Access Compliance Report

Public Rights-of-Way

Intersection ID: 10038349	Main Street: SOUTH_BV	Cross Street: N/A	Location: E
ADA ID: 35D1409942C9	Ramp Type: Perp	Initial Pass/Fail: Fail	Overall Compliance: No
		Severity Score: 12.5

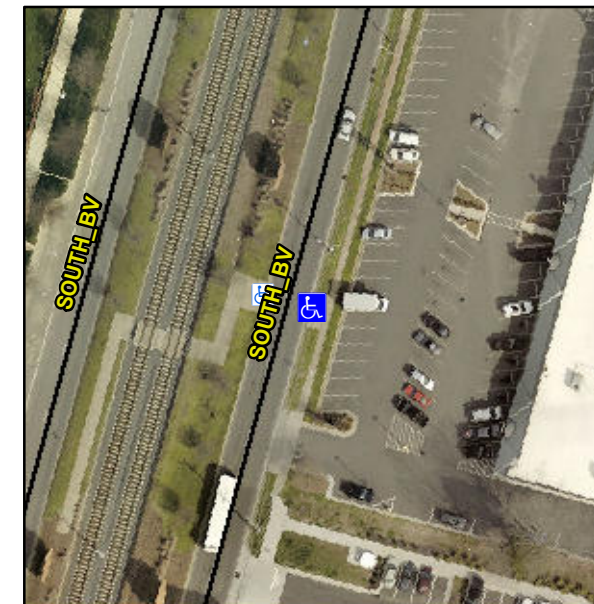
Not Found, R304.2.2

Compliance	Description	Data	Compliance	Description	Data
N/A	Ramp Length (in)	79.0	No	Ramp Slope (%)	8.6
Yes	Ramp Width (in)	84.0	Yes	Ramp XSlope (%)	2.0
N/A	Flare Type LT	N/A	N/A	Flare Type RT	N/A
N/A	Flare Slope LT (%)	N/A	N/A	Flare Slope RT (%)	N/A
N/A	Flare Traversable LT?	N/A	N/A	Flare Traversable RT?	N/A
N/A	Landing Length (in)	N/A	N/A	DWS Provided?	N/A
N/A	Landing Width (in)	N/A	N/A	DWS Contrast?	N/A
N/A	Landing Slope (%)	N/A	N/A	DWS Length (in)	N/A
N/A	Landing X Slope (%)	N/A	N/A	DWS Full Width?	N/A
N/A	Landing Curb? (Y/N)	N/A	N/A	DWS Offset (in)	N/A
N/A	Shared Landing?	N/A			
N/A	Gutter Ponding?	N/A	N/A	Gutter Slope (%)	N/A
N/A	Gutter Lip Ht (in)	N/A	N/A	Gutter X Slope (%)	N/A
N/A	Painted X Walk1?	No	N/A	Painted X Walk2?	N/A
	X Walk 1 Direction	To W		X Walk 2 Direction	N/A
N/A	X Walk 1 Width (in)	N/A	N/A	X Walk 2 Width (in)	N/A
	X Walk 1 Slope (%)	0.5		X Walk 2 Slope (%)	N/A
	X Walk 1 X Slope (%)	0.3		X Walk 2 X Slope (%)	N/A

Remove & Replace Entire Ramp.
